Access Compliance Report

Public Rights-of-Way

Intersection ID: 42365	Main Street: CARDINALS_NEST_DR	Cross Street: KESTRAL_RIDGE_DR	Location: SW
ADA ID: 8032B3AB94B5	Ramp Type: PerpDiag	Initial Pass/Fail: Fail	Overall Compliance: No
		Severity Score: 12.5

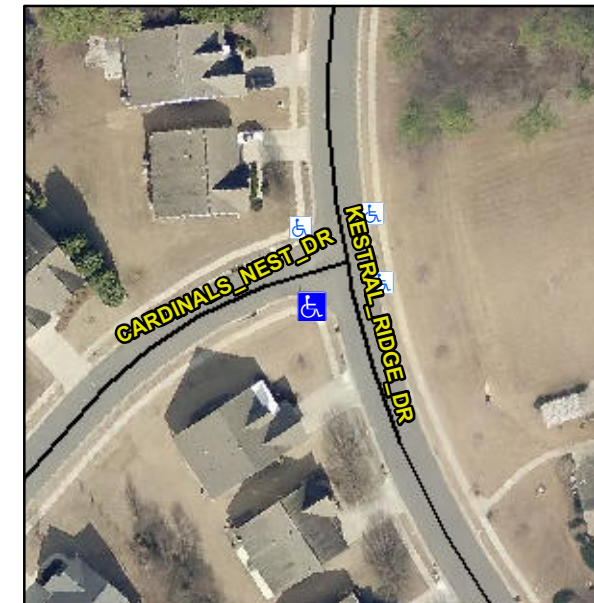
Not Found, R304.5.3

Compliance	Description	Data	Compliance	Description	Data
N/A	Ramp Length (in)	42.0	Yes	Ramp Slope (%)	6.5
Yes	Ramp Width (in)	58.0	No	Ramp XSlope (%)	5.2
N/A	Flare Type LT	N/A	N/A	Flare Type RT	N/A
N/A	Flare Slope LT (%)	N/A	N/A	Flare Slope RT (%)	N/A
N/A	Flare Traversable LT?	N/A	N/A	Flare Traversable RT?	N/A
N/A	Landing Length (in)	N/A	N/A	DWS Provided?	N/A
N/A	Landing Width (in)	N/A	N/A	DWS Contrast?	N/A
N/A	Landing Slope (%)	N/A	N/A	DWS Length (in)	N/A
N/A	Landing X Slope (%)	N/A	N/A	DWS Full Width?	N/A
N/A	Landing Curb? (Y/N)	N/A	N/A	DWS Offset (in)	N/A
N/A	Shared Landing?	N/A			
N/A	Gutter Ponding?	N/A	N/A	Gutter Slope (%)	N/A
N/A	Gutter Lip Ht (in)	N/A	N/A	Gutter X Slope (%)	N/A
N/A	Painted X Walk1?	No	N/A	Painted X Walk2?	No
	X Walk 1 Direction	To E		X Walk 2 Direction	To N
N/A	X Walk 1 Width (in)	N/A	N/A	X Walk 2 Width (in)	N/A
	X Walk 1 Slope (%)	2.3		X Walk 2 Slope (%)	1.4
	X Walk 1 X Slope (%)	1.2		X Walk 2 X Slope (%)	0.4

Remove & Replace Curb Ramp With Two New Directional Ramps or Equivalent.
